Model: Adonis-C3V2		Date: 1-Aug-03	No.: MB135001
Modified Article: P/N differences: A-C3 c/d vs. e/f mainframe		Prepared by: Y.Urushihara	
From: 1st Tech. Support Sec. Service Support Dept.			
Reason for Modification:	☐ Parts catalog correction ☐ To facilitate assembly ☐ Part standardization	☐ Vendor change ☐ To improve reliability ☒ Other	☐ To meet standards ()

Please note the following P/N differences between the Model A-C3c/d and e/f mainframes, and the P/C title revisions on the last page of this bulletin.

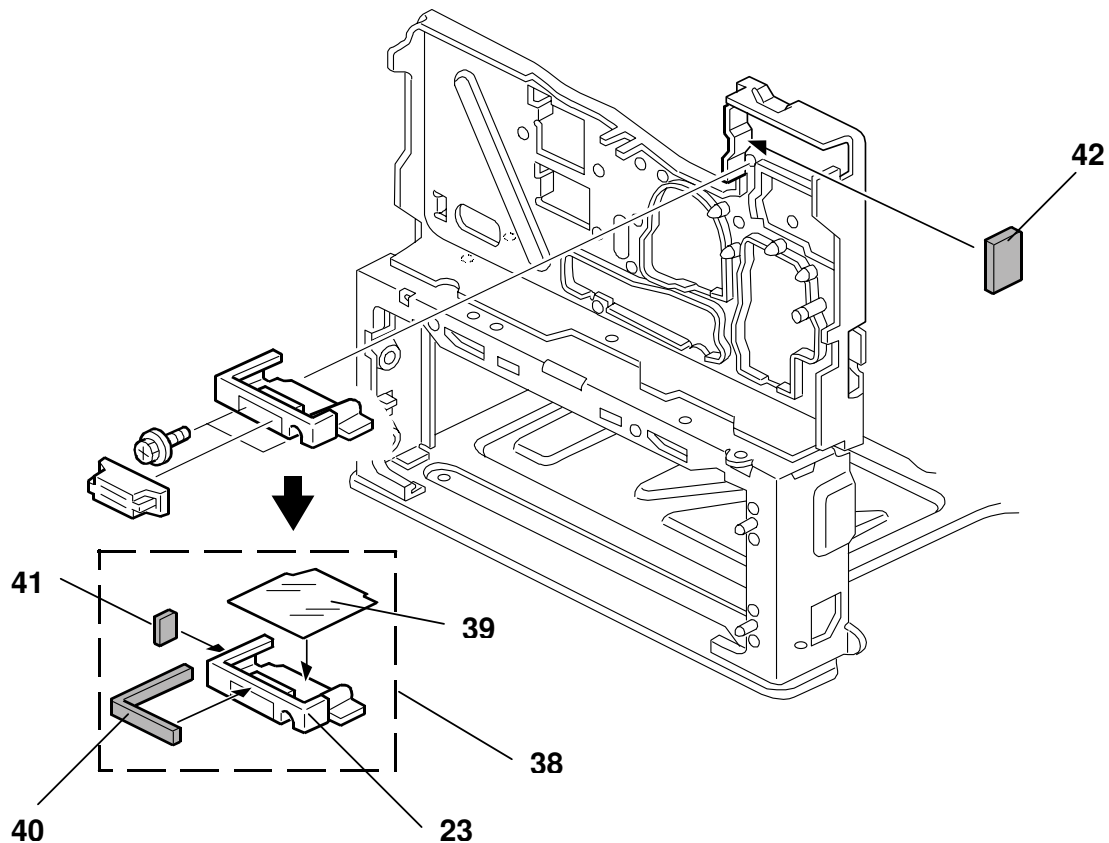
The following has been changed due to a vendor change

Old part number	New part number	Description	Q'ty	int	Page	Index	Note
B0825218	B101 5257	LCD HVGA SH BL	1	O/O	17	6

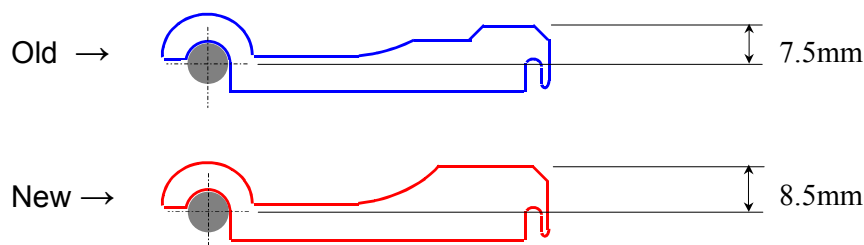
Change: Shape of the pressure lever.

Reason: To further ensure that the gap between the fusing hot roller and fusing pressure roller is normal.

Note: If the gap is too wide, streaks can occur on copies.

Old part number	New part number	Description	Q'ty	Int	Page	Index	Note
B0774056	B0824160	Lever: Pressure	2	X/O	51	23

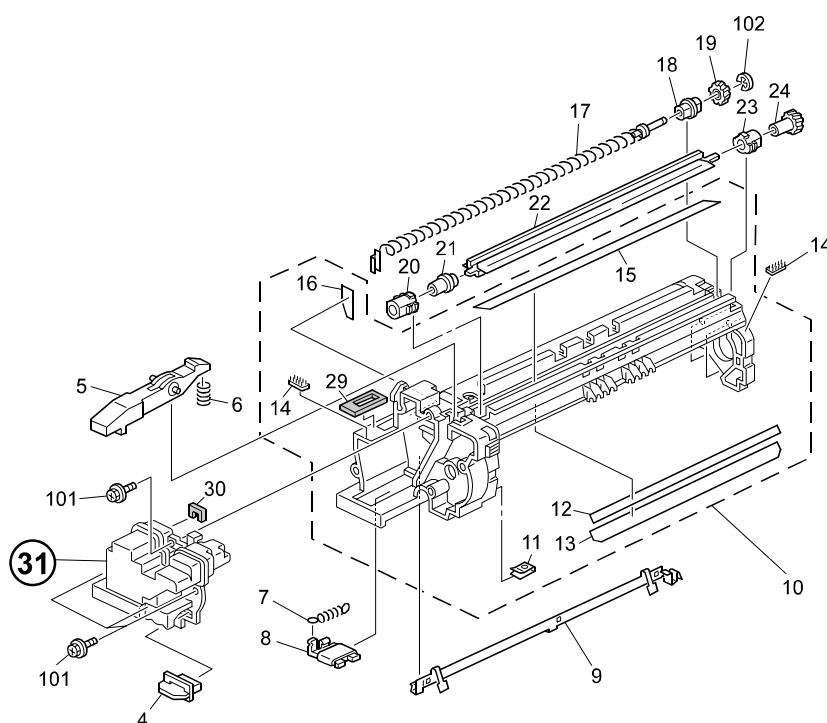
Please note the following revision made to the A-C3e/f Parts Catalog, which was applied from the beginning of mass production.

Old part number	New part number	Description	Q'ty	Int	Page	Index	Note
	B0823255	Developer Cartridge – sub ass'y	0-1		43	31

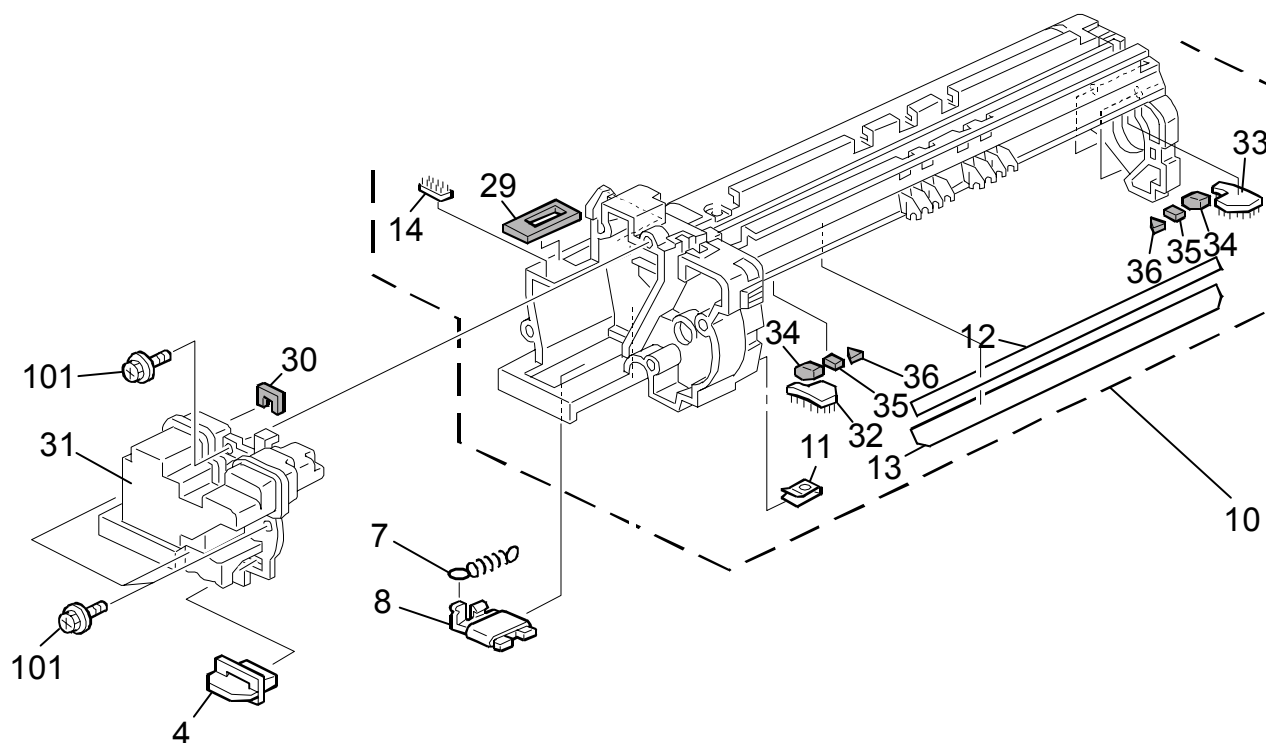
Part number	Description	Q'ty	Int	Page	Index	Note
G0652233	Seal Drum Front	1		43	32	
G0652234	Seal Drum Rear	1		43	33	
A2322399	Seal – Blade 13x9.5x3	2	-	43	34	
A2322348	Seal Blade 12x7x3	2	-	43	35	
A2322350	Seal - Entrance	2	-	43	36

Change/Reason: The descriptions for these parts were missing from the Parts Catalog.
